**1994 Chevrolet Caprice V8-350 5.7L**

Bulletin No.: 377142A

**SUBJECT:  
NEW TRANSMISSION OIL FILTER ASSEMBLY**

**TRANSMISSION APPLICATIONS:  
1994 HYDRA-MATIC 4L60-E (M30)**

**Figure 1**

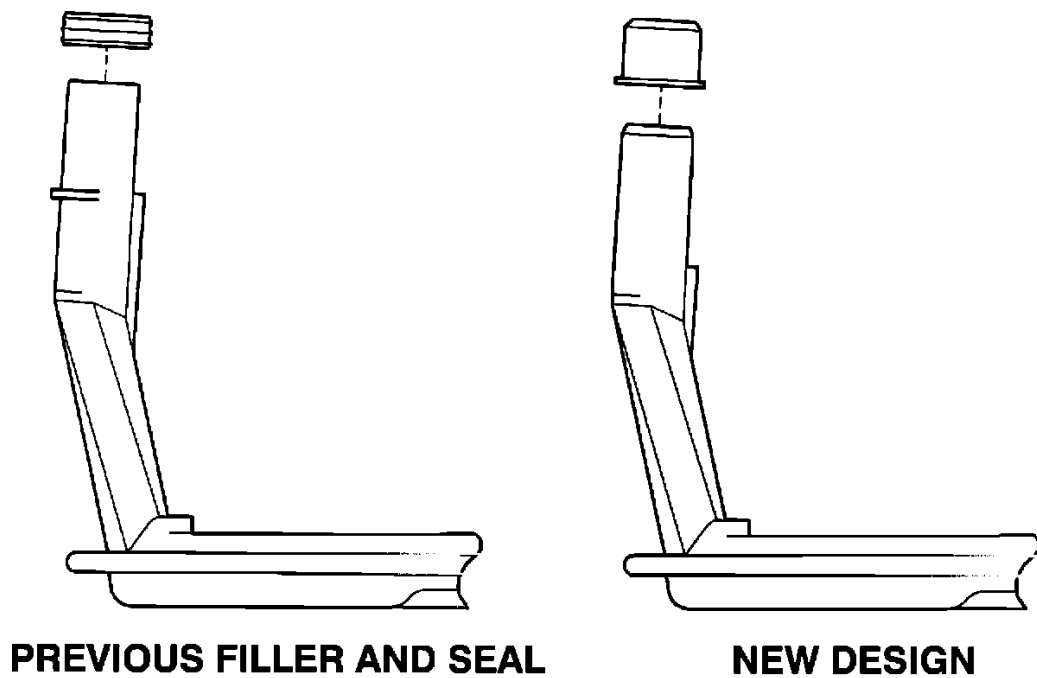
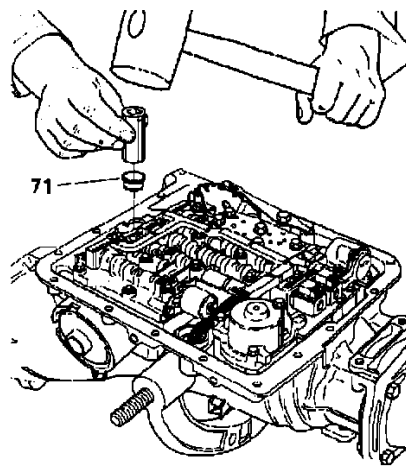
**DATE OF PRODUCTION CHANGE:**  
(Figure 1 and 2)

On August 10, 1993 (Julian Date 222), HYDRA-MATIC 4L60-E transmissions were built with a new filter seal (ill. 71) and transmission oil filter assembly (ill. 72).

The previous transmission oil filter assembly and filter seal had an assembly method of installing the seal on the filter neck and then installing the filter in the transmission.

When using the new filter seal and transmission oil filter assembly, the filter seal must be installed in the transmission first and then install the transmission oil filter assembly into the transmission.

The new filter seal and transmission oil filter assembly can be used on all HYDRA-MATIC 4L60-E transmissions 1993-1994. The new filter seal and transmission oil filter assembly cannot be used on any HYDRA-MATIC 4L60 transmission.

The new filter seal cannot be used with the old transmission oil filter assembly and the new transmission oil filter assembly cannot be used with the old filter seal.
